| Title - Sujet PeSakastew Parking Lot Expansion | |
| Solicitation No. - N° de l'invitation EW038-160303/A | Amendment No. - N° modif. 003 |

Addendum # 1

| Subject | Pe Sakastew – Tender Addendum Items |

Overall Site Plan

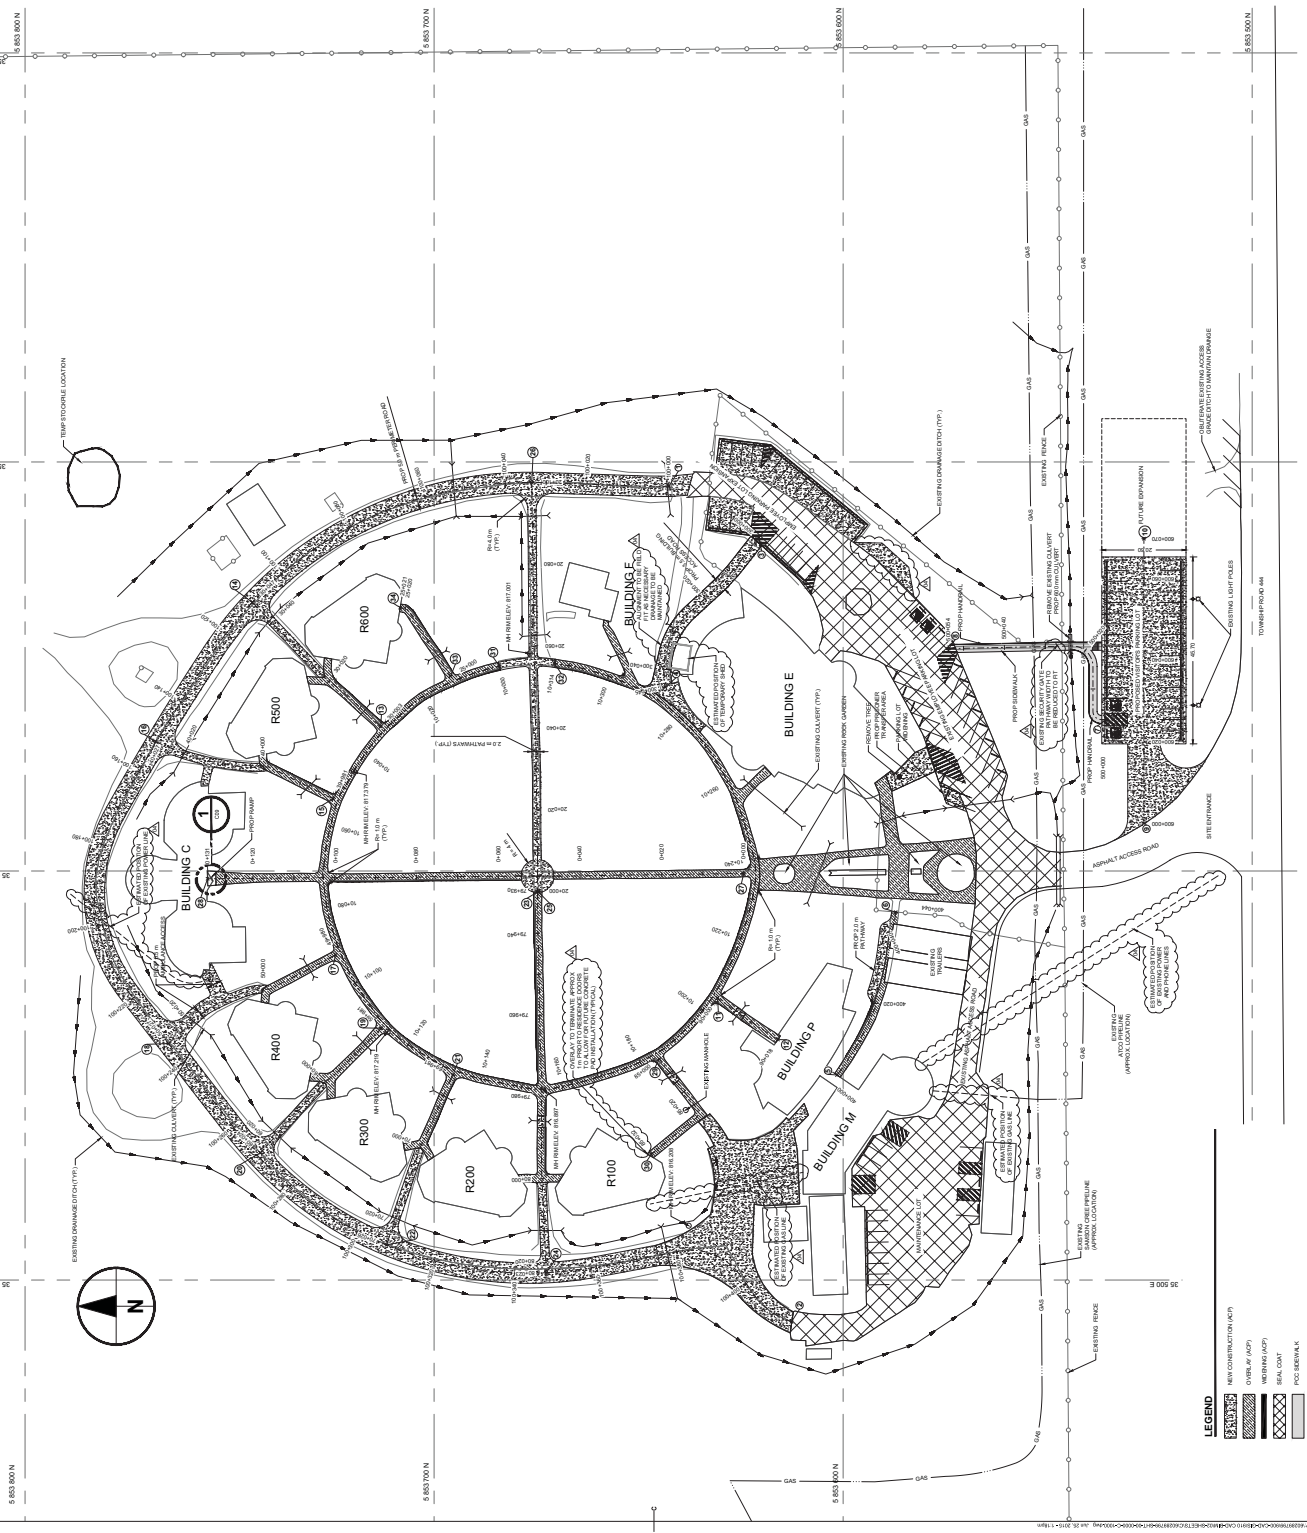
7. Final alignment for the proposed 3.5 m Building Access Road from Employee Parking Lot to be field adjusted to deviate around existing temporary maintenance shed. As indicated on revised drawing C02. Replace existing Drawing C02 with the attached & Updated Drawing C02
